68-485 Removal and installation of trim on rear center piece

68 Lining

68-87021 Lining in cargo space, left, closes poorly, hooks for hanging up break.

Model -
124
T-sedan

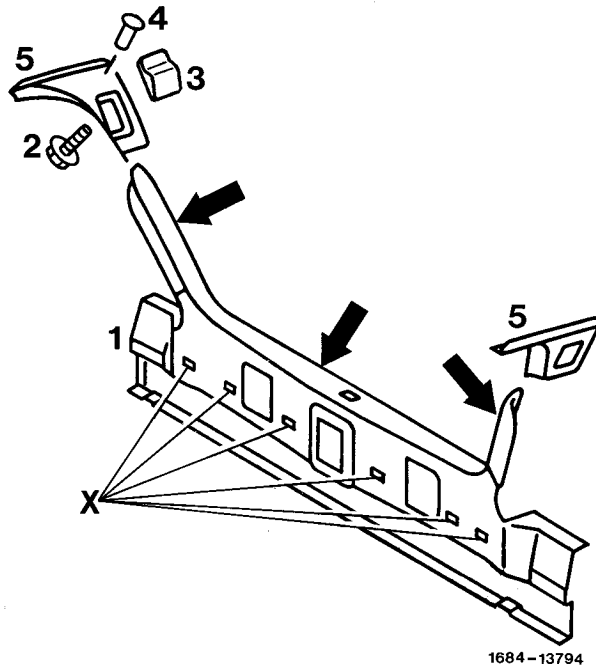
Note: Broken off plastic hooks (x) can be replaced with plastic dowels, part no. 001 997 39 86.

68-88021 Noises in belt height adjustment.

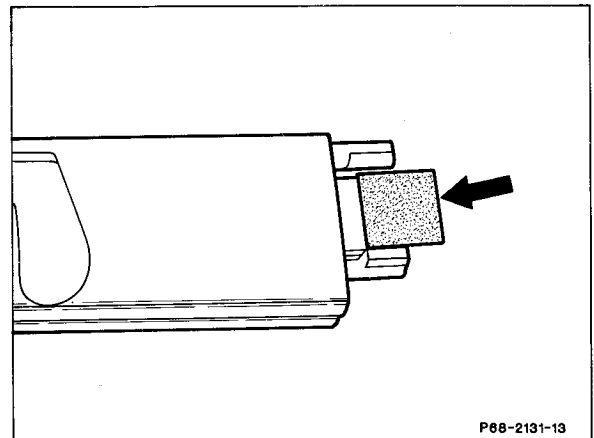
Too much clearance of slide in center pillar lining.

Glue felt to link of slide.

68-88051 Spare wheel lining (modified version) cannot be locked on vehicles manufactured prior to 10/86.

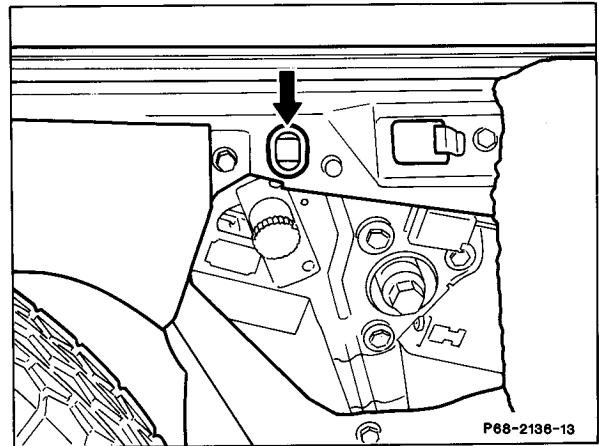
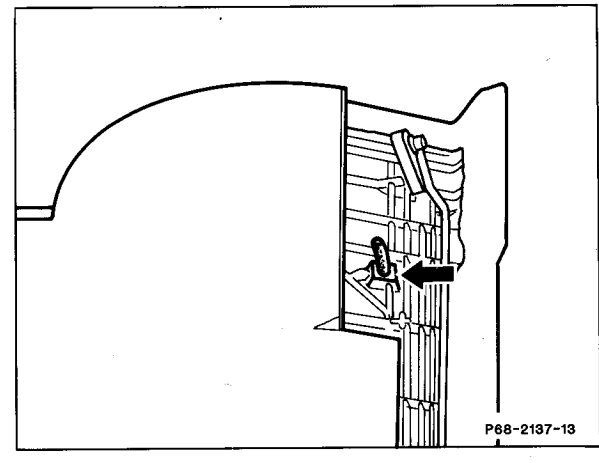
Oval opening in side wall for plastic bolt on lining missing (Fig.).

Cut off plastic bolt on lining (Fig.).

Production breakpoint of oval opening in side wall: 10/86 or vehicle ident end no. F 023 266.

68-89121 Noises in belt height adjustment.

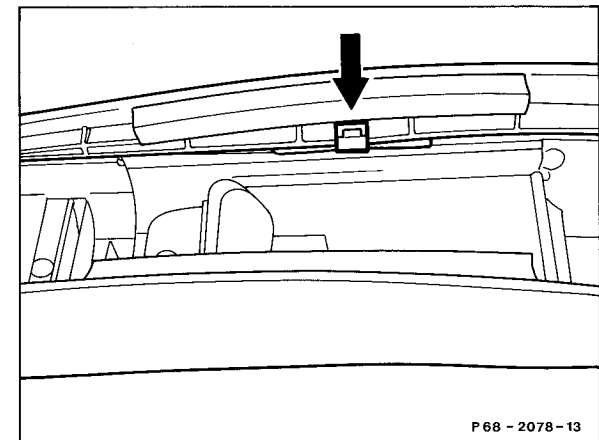
Too much play of slide in center pillar lining.

Install holding clamps (2 each), part no. 124 988 93 78, in center of slide guide.

Production breakpoint: 10/89

68-90071 Scissors-type roller blind does temporarily not attain the fully retracted position.

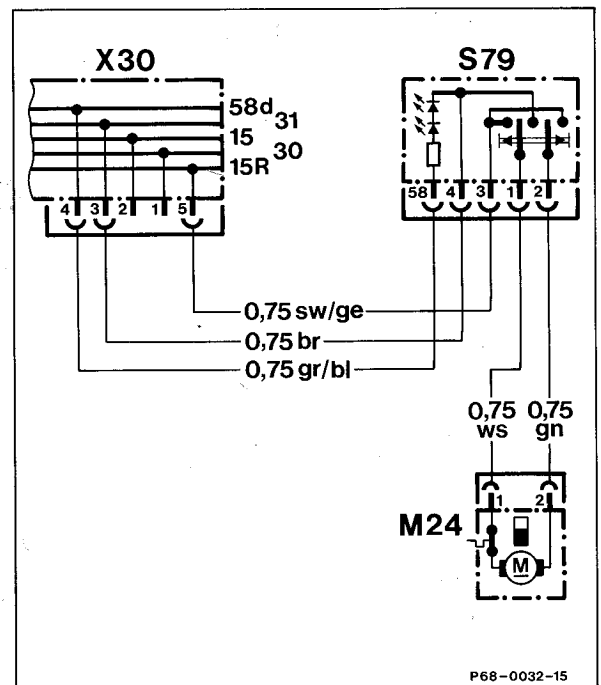
1. Upper cover above roller blind blocks roller blind during retraction.
2. The sliding rollers on upper roller blind cross bar for support in the upper range are not continuously running along rear window, so that the scissors will press against the roller blind lining during retraction.

1. Press down upper cover above roller blind in correct position.
2. Remove roller blind, then connect roller blind and extend. Bend both scissors slightly toward the rear, reinstall roller blind. If remedial measures prove to be ineffective, inquire further measures from KD-50 telephone 07031/90-5514 or 2343.
